Stag Brewery, Mortlake

Masterplan and Detailed Design and Access Statement - Addendum

Fire-Led Design Amendments

November 2023

Proposed Scheme - Building 02 Typical Floor Plan

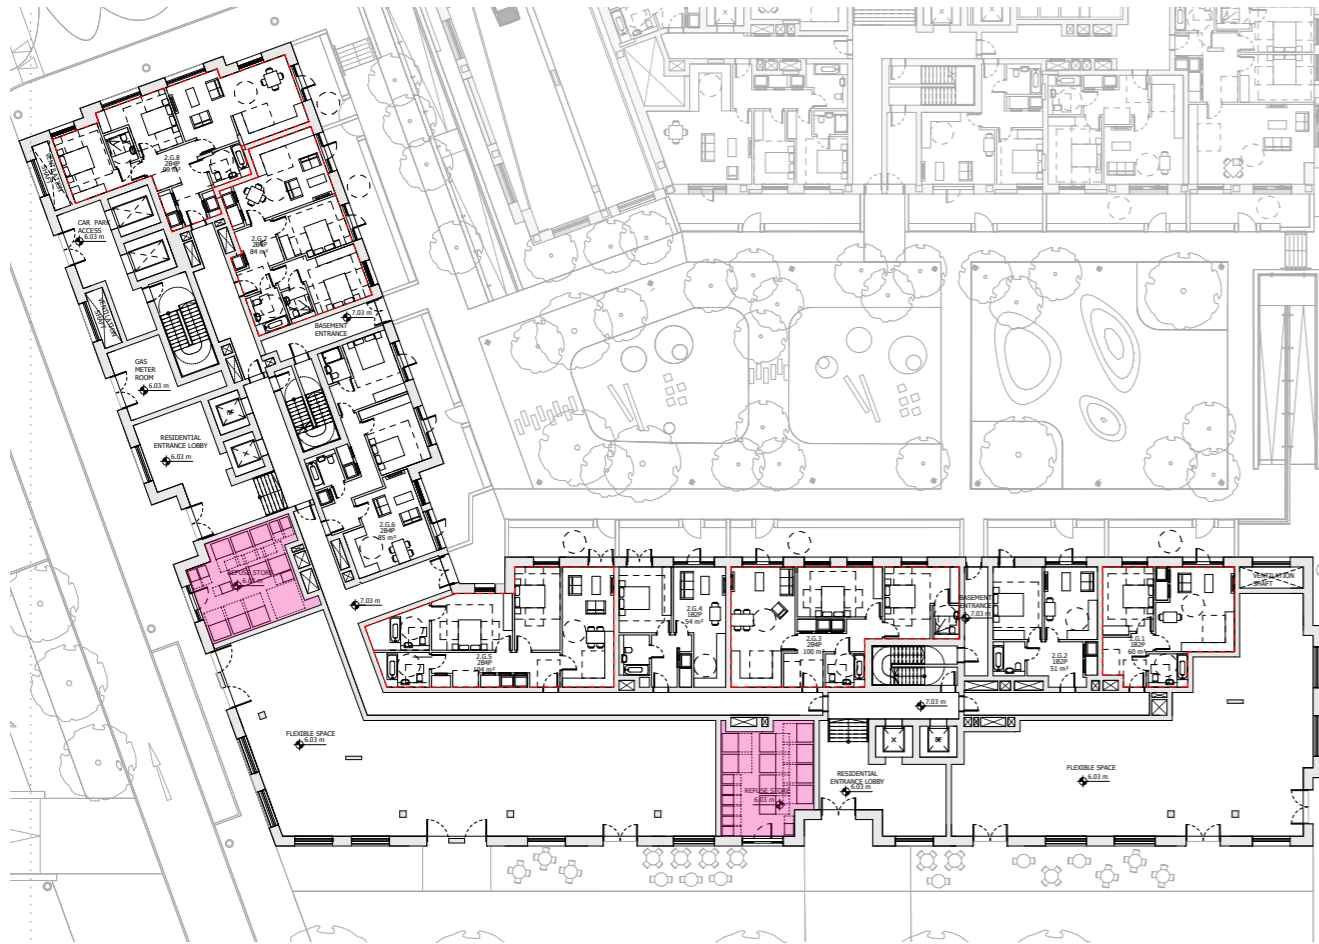
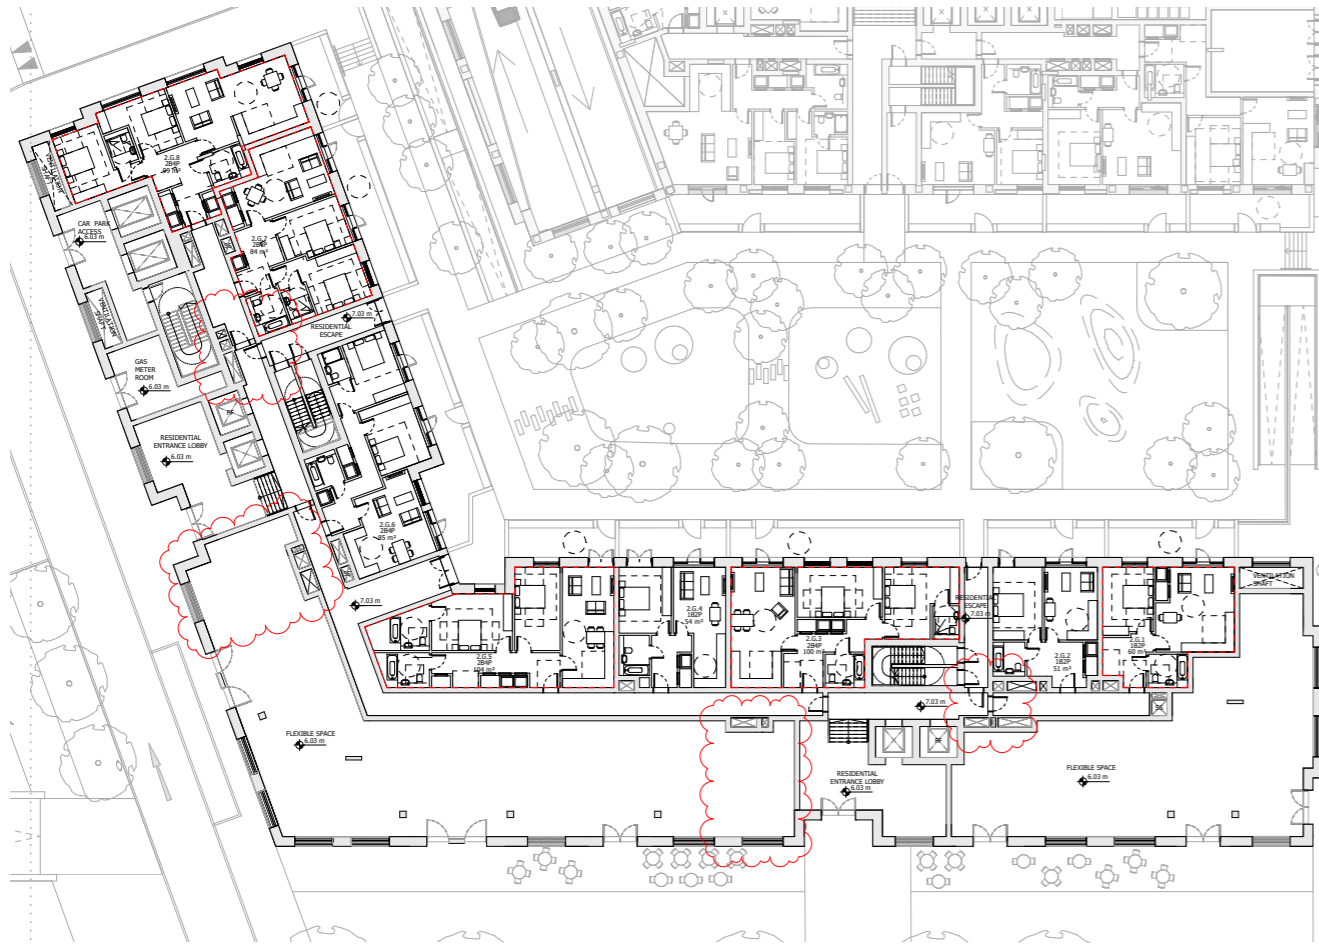
In the committee scheme Building 02 had two separate cores with no connection between the two. The revised proposal connects the two cores together by extending the corridors, as shown here on the typical plans, so that all apartments have access to two stairs in case of emergency. The corridor is separated in the middle by a fire rated door which would only open when a fire alarm is triggered, therefore ensuring that on a day-to-day basis there are no more than 8 units per floor around each core.

These changes have resulted in one additional unit on the 7th floor as the 3 bed through unit in the centre of the building has been split into two 1 beds by the extended corridor. This has not changed the number of habitable rooms.

The committee scheme proposed a duplex apartment on the corner of the building on the 7th floor. As part of these amendments we have removed the habitable space from the 8th floor as this space could only be accessed by the Fire Brigade from the level below which is not supported by current guidelines. The external appearance of the 'turret' has remained as per the committee scheme as a marker to the start of the Green Link. Options for re-introducing habitable space to the 8th floor may be revisited once emerging fire legislation is clarified. This change has not impacted the number of units or habitable rooms in this building.

Proposed Scheme - Building 04 Typical Floor Plan

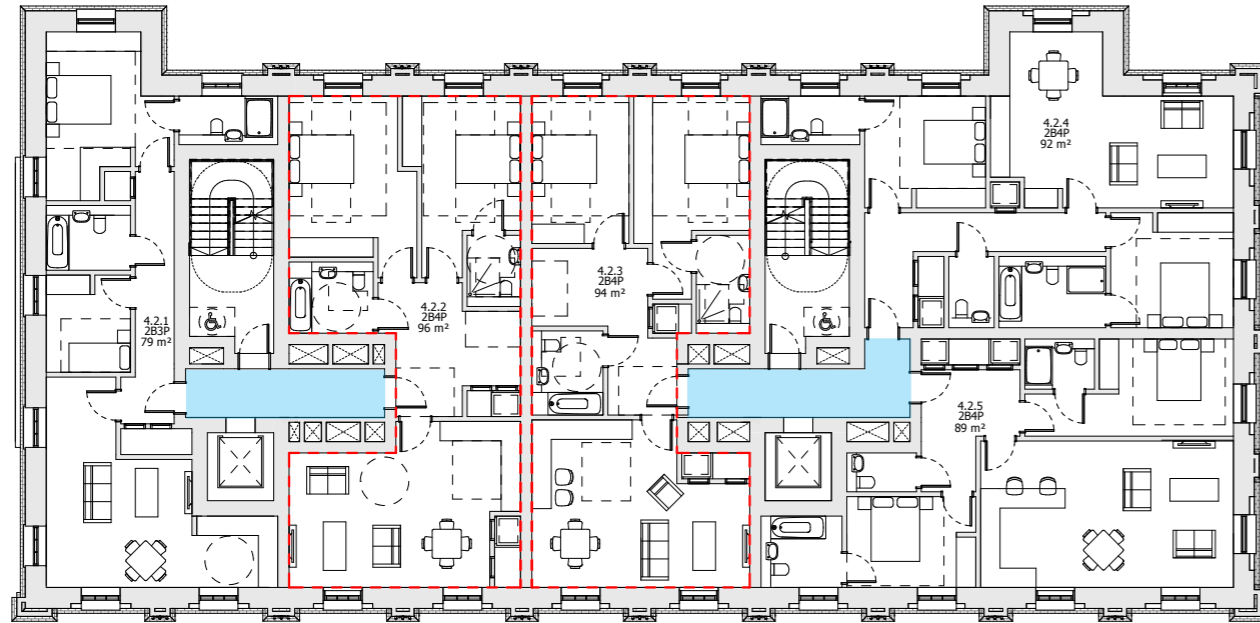
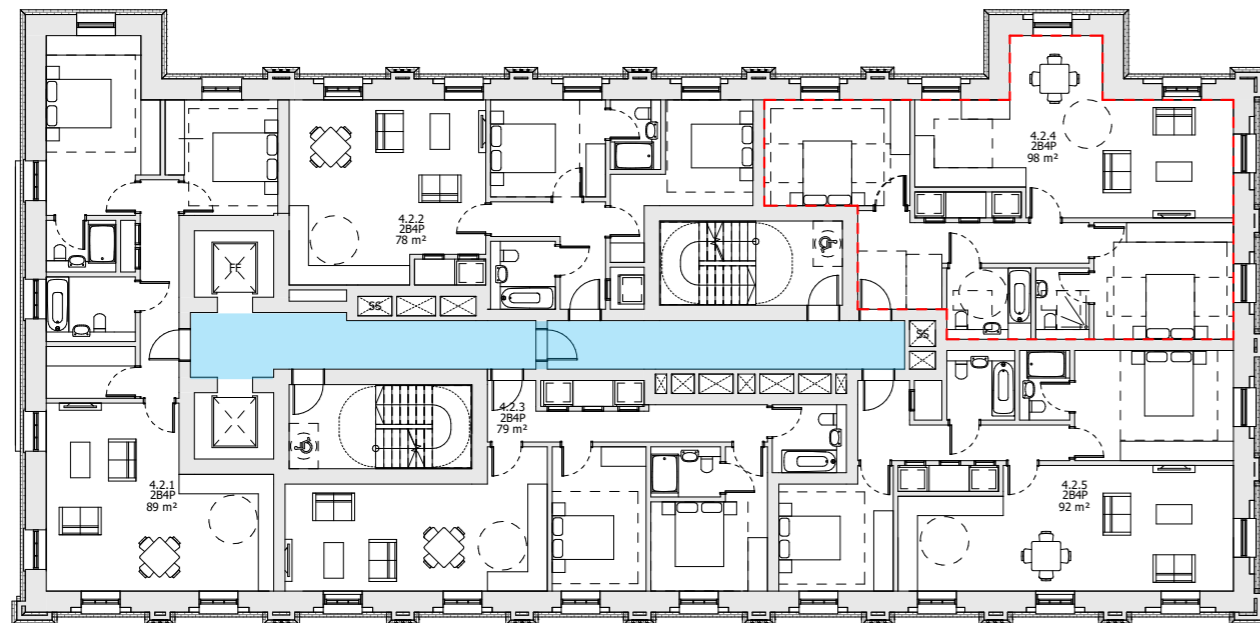
Similarly to Building 02, the two separate cores of Building 04 have been connected to ensure that each apartment is served by two staircases. The lifts have been moved to the east side of the building, which is taller, to ensure that the lift overruns can be accommodated within the external envelope. The through units at the centre of the plan have been updated to two single aspect units due to the lengthening of the corridor. These changes have not impacted the number of units or habitable rooms in this building.

Proposed Scheme - Building 04 Ground Floor Plan

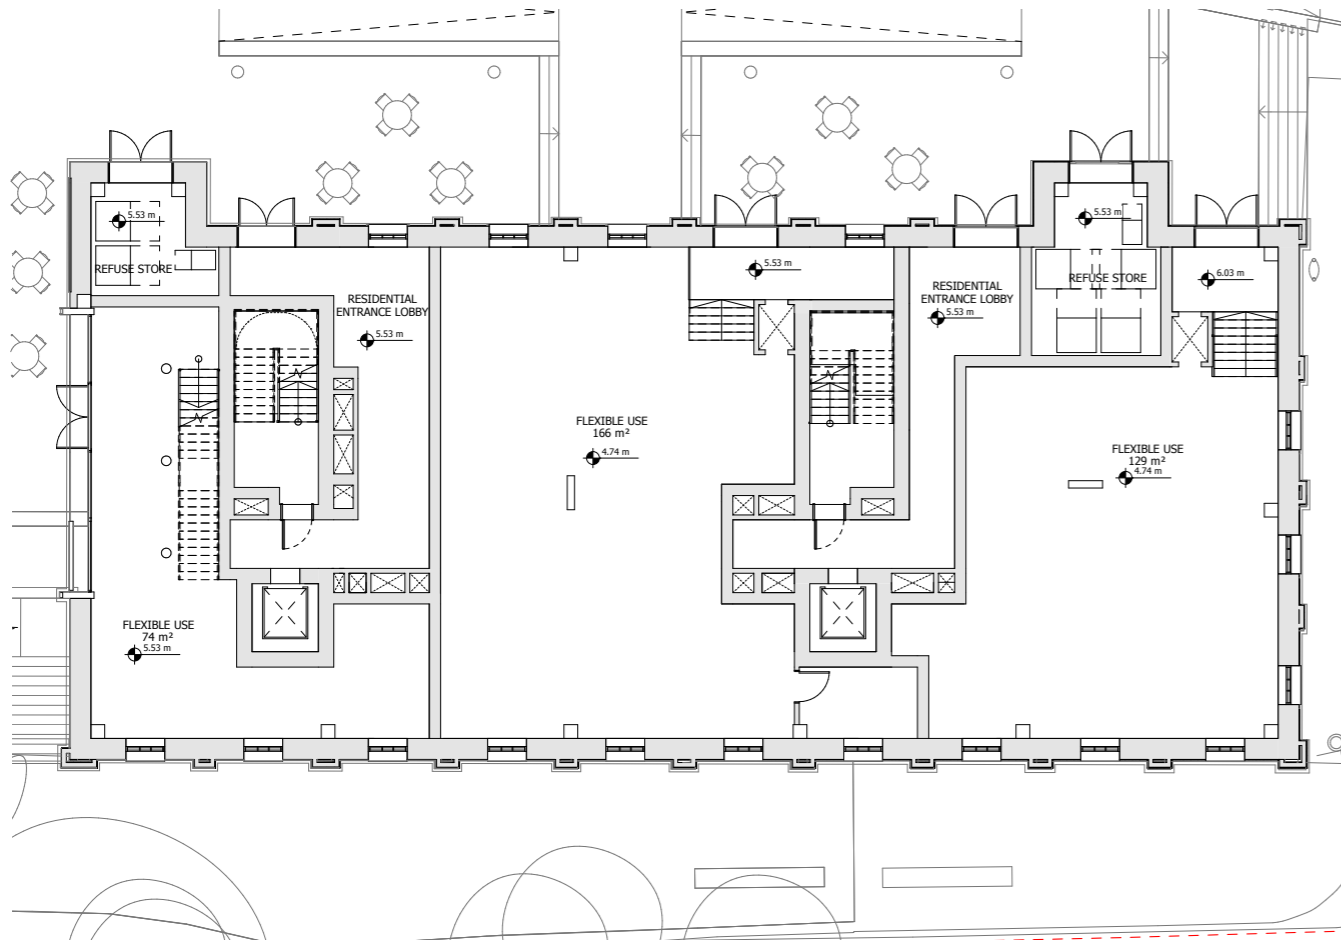
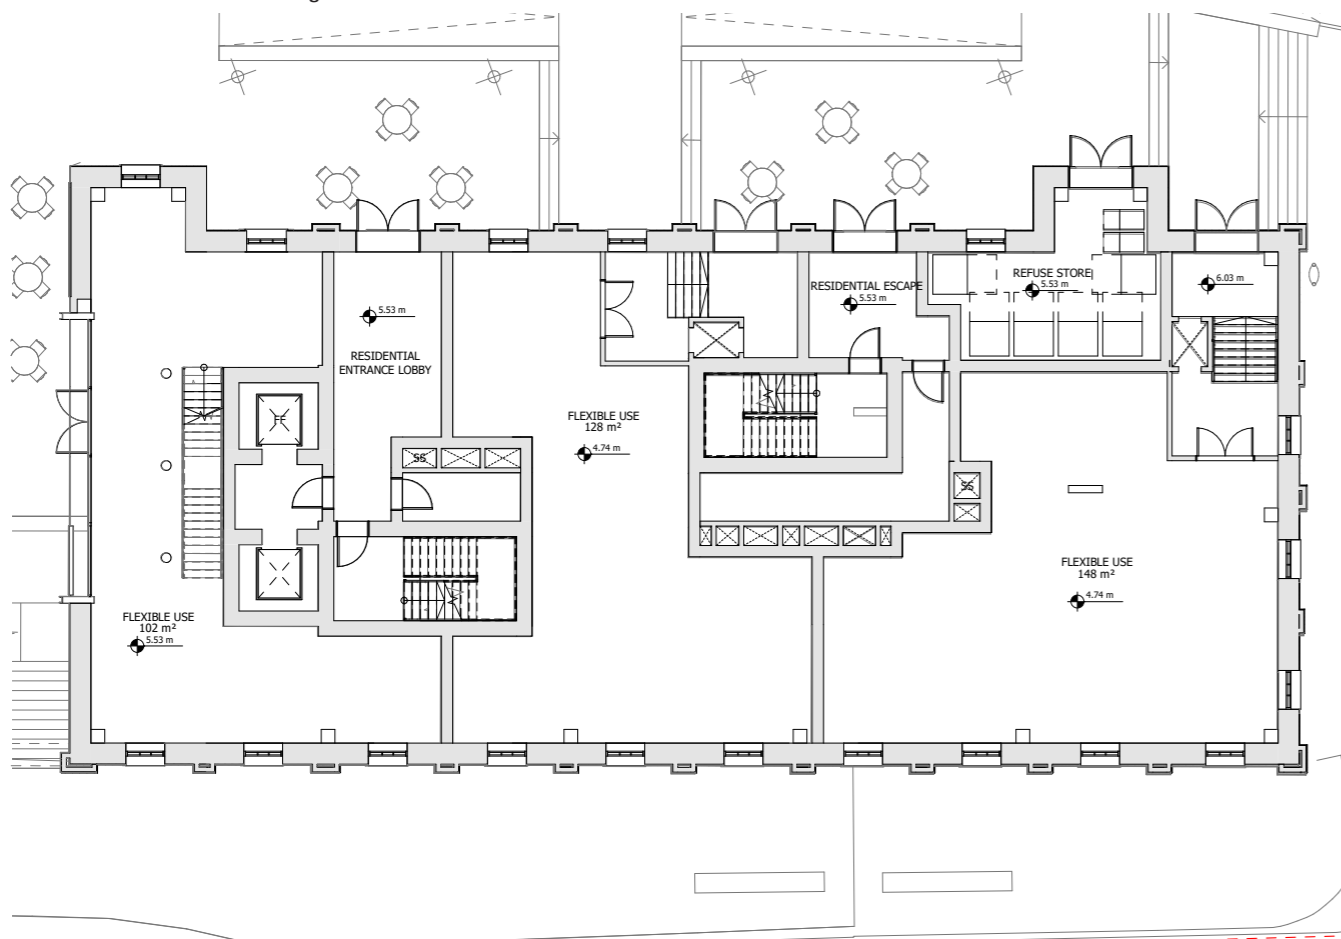
The changes to the residential cores have had a knock on impact to the ground floor plan however the design intent remains the same with 3 dual aspect flexible use units proposed with an increase of 11m² flexible use GIA in total.

Proposed Scheme - Building 04 North Elevation

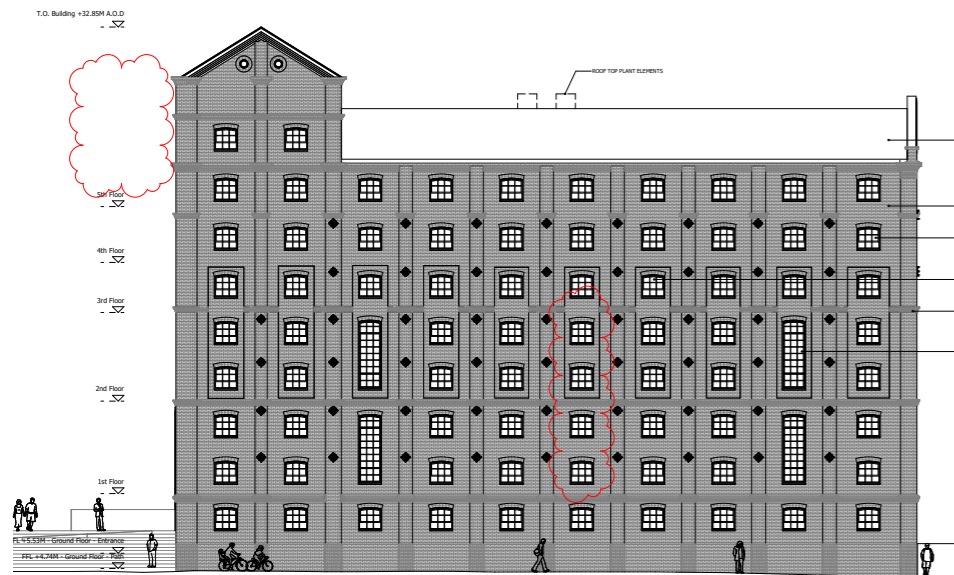
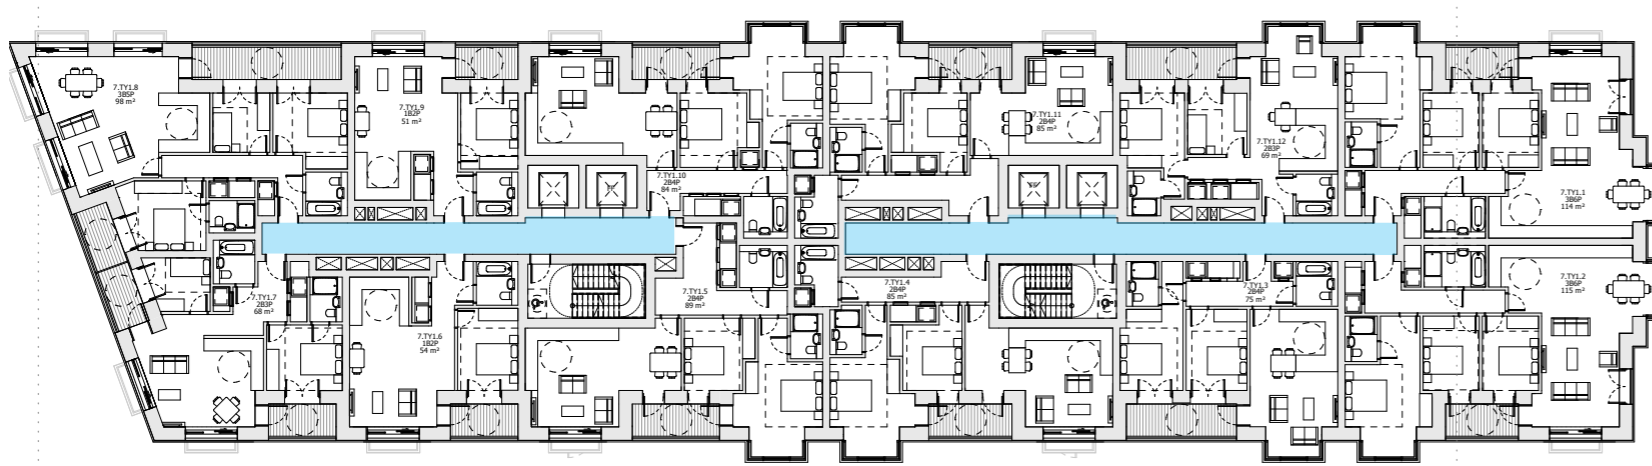
The change in layout mentioned previously to the central apartments on each floor has resulted in some minor changes to the north and south elevations. The committee scheme proposed combining a few existing windows together to make taller vertical windows in the living spaces of some of the units due to the relationship between the height of the existing windows and the proposed floor levels. These amendments propose to return two sets of windows on the north facade to their existing size and introduce an additional instance of the taller windows to the south facade due to changes in location of living spaces. This strategy is consistent with the committee scheme.

The current proposals also remove the duplex apartment which was on the 6th and 7th floors of this building (highlighted in yellow) as this unit could not be accessed by two staircases due to the small footprint of these upper floors. Therefore there is one less unit in this building compared to the committee scheme.

Proposed Scheme - Building 07 Typical Floor Plan

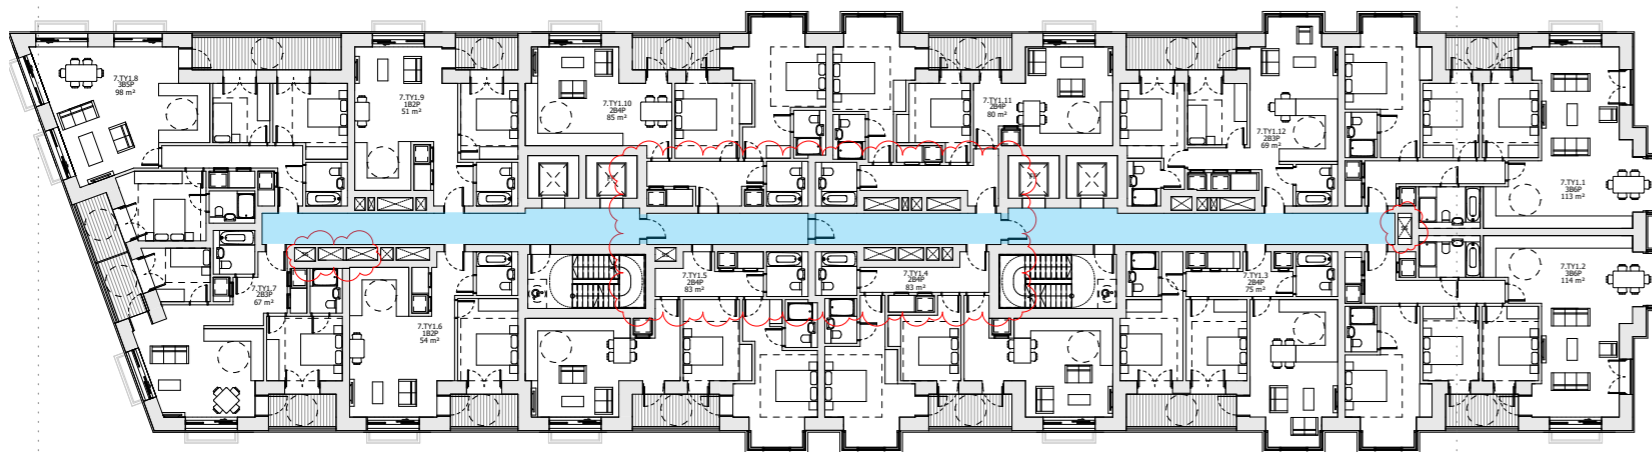
Similarly to Building 02, the two separate cores proposed in Building 07 have been connected to provide access to both staircases for all of the apartments.

The top floor of the duplex unit in the 'turret' has also been removed in the same way as in Building 02.

Neither of these changes have impacted the number of units or habitable rooms in this building.

Proposed Scheme - Building 07 Ground Floor Plan

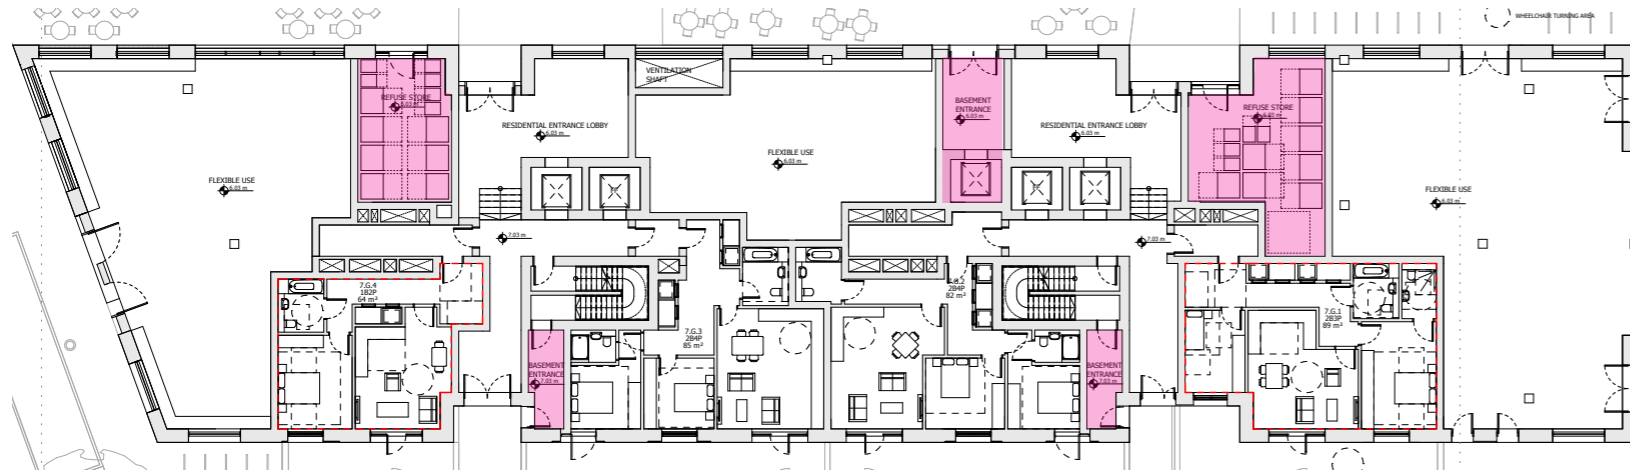
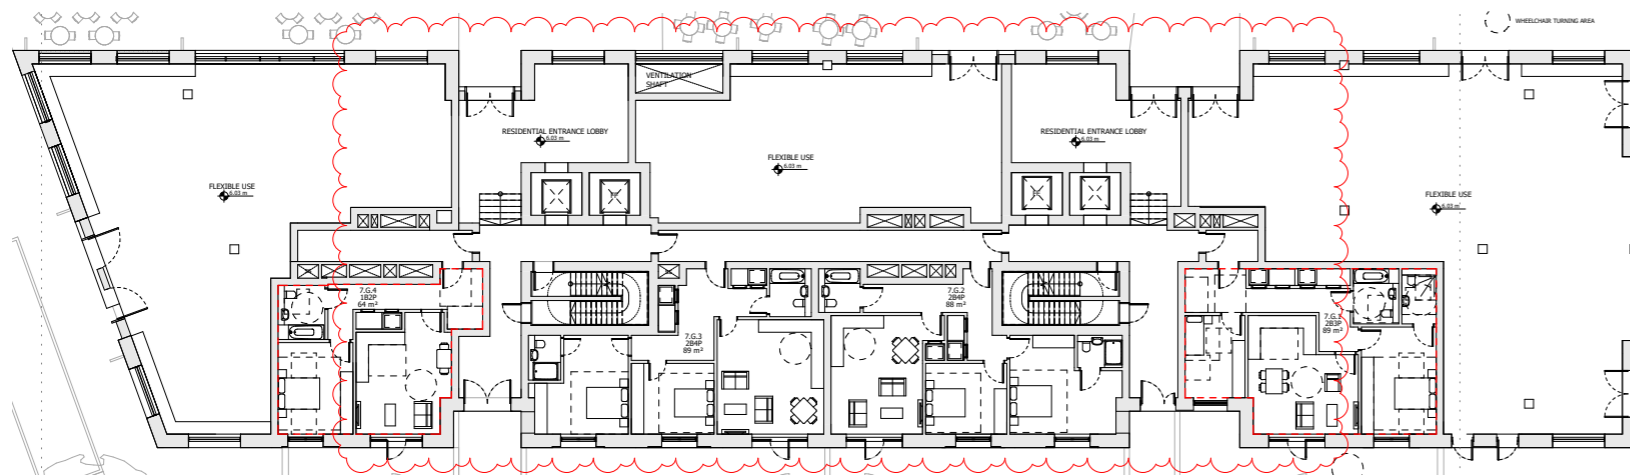
As with Building 02 the refuse stores have been returned to the basement and the lifts have been extended back down to the basement now that this building has two staircases. This has resulted in additional GIA to the flexible use units at ground.
